**CALIFORNIA INSTITUTE OF TECHNOLOGY
MASSACHUSETTS INSTITUTE OF TECHNOLOGY**
Laser Interferometer Gravitational Wave Observatory (LIGO) Project

To/Mail Code:	
From/Mail Code:	Daniel Sigg
Phone/FAX:	
Refer to:	LIGO-T040129-A
Date:	June 19, 2004

NEW ISCT4 LAYOUT AND AS SIGNAL PATH

Figure 1: Schematic view of current H1 ISCT4 layout.

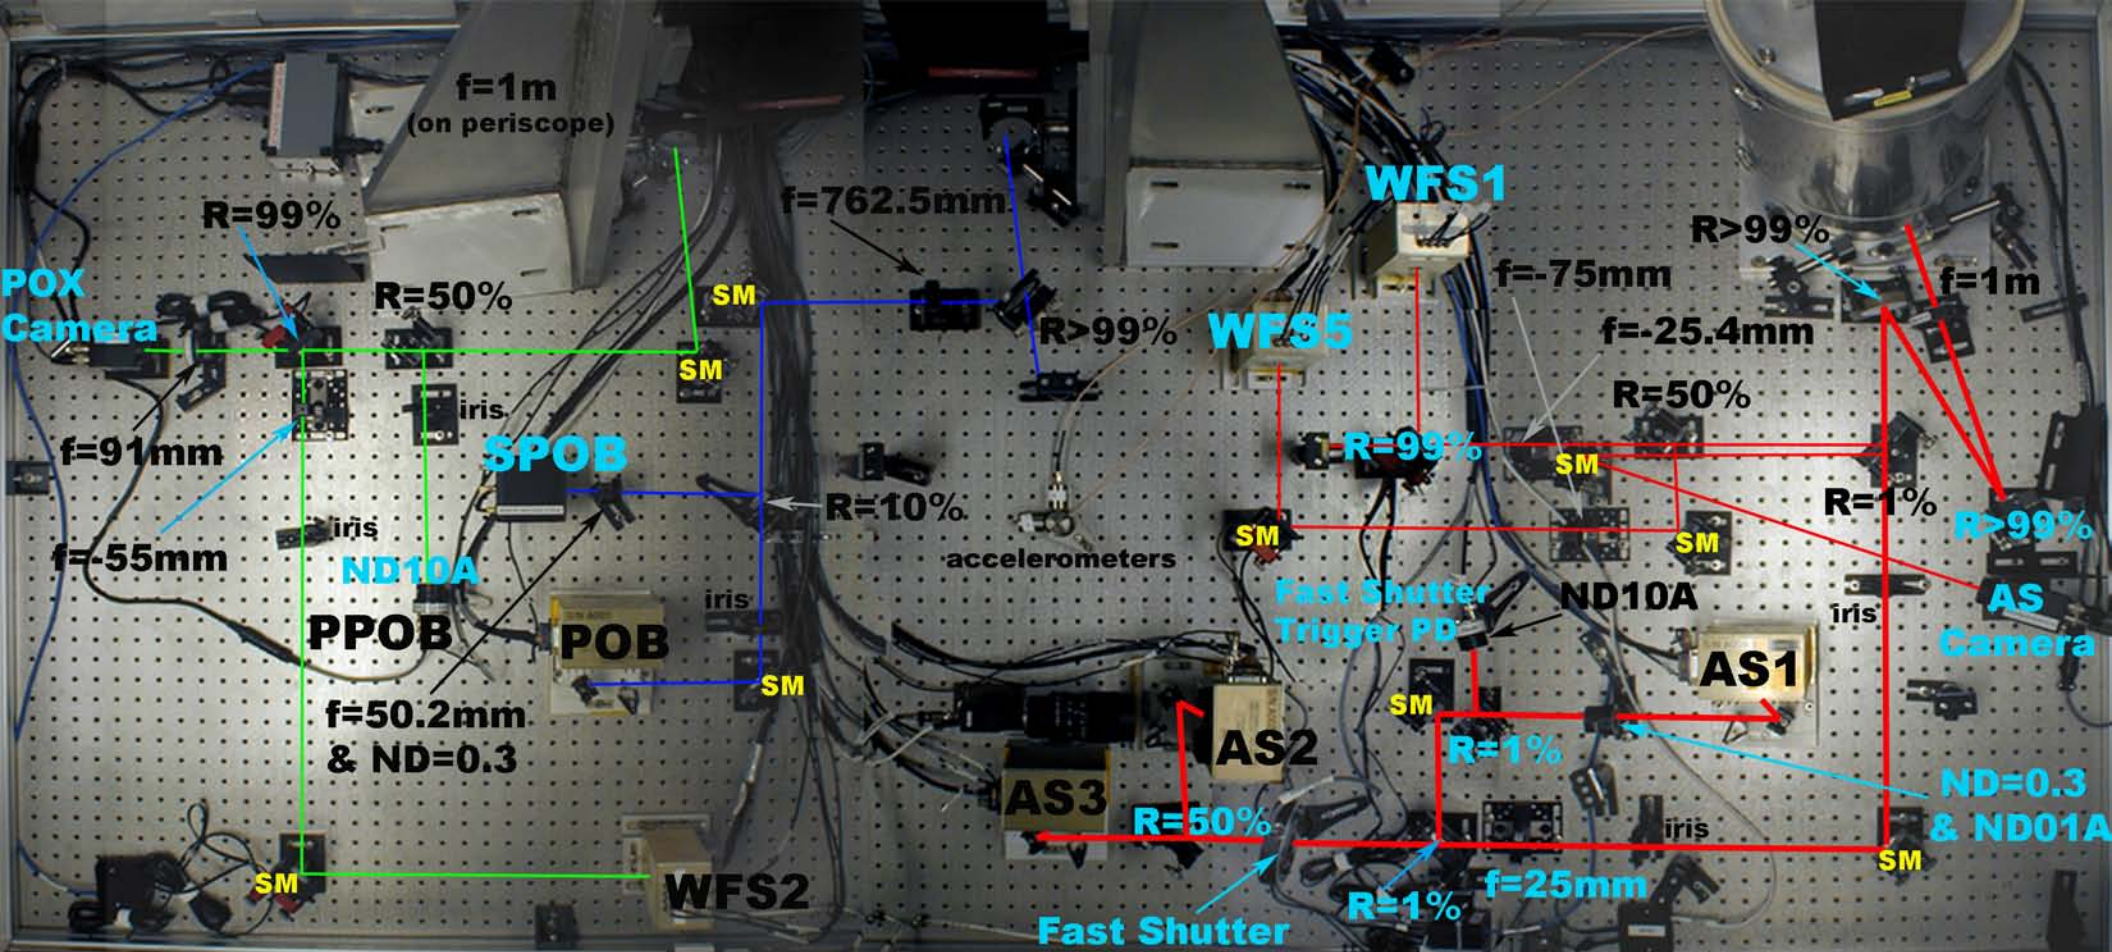
Figure 1 presents the current layout of ISCT4. It doesn't include the OMC which uses the AS PD2 path.

Figure 2: Schematic view of the H1 ISCT1 layout (AS path only).

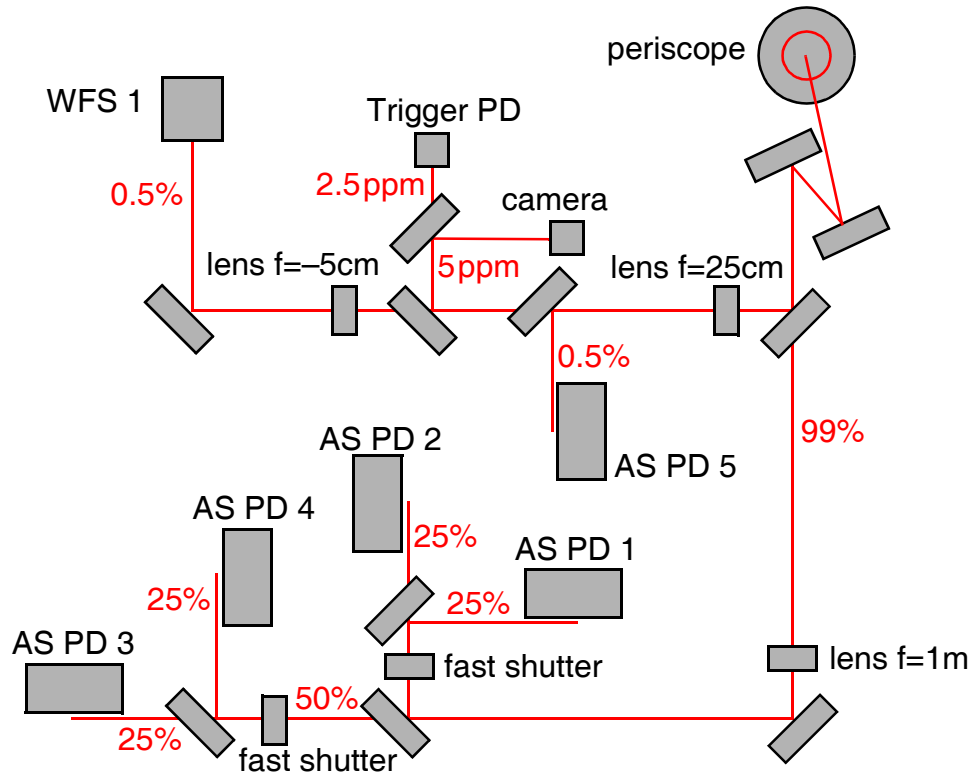
To accommodate a total of four photodetectors at the anti-symmetric port for detection we propose a new layout of ISCT4. To minimize the coupling from dust particles falling through the beam we avoid an intermediate focus.

Figure 2 presents the new layout of ISCT4. The main features are:

- The focusing lens has been moved after the WFS split. The WFS path implements a new 600mm lens whereas the LSC path keeps the 1000mm lens. There is no intermediate focus anymore in the LSC path.
- The locking PD moves to the old WFS5 path and is now called AS PD5. The trigger PD is moved to the WFS path as well.
- New photodetectors for detection are installed in the LSC path: AS PD 1 and AS PD 4.
- The diverging lens in front of WFS1 is moved back to account for the translation and change of focal length of the upstream lens.
- The OMC work can be continued at the AS PD2 path if necessary.
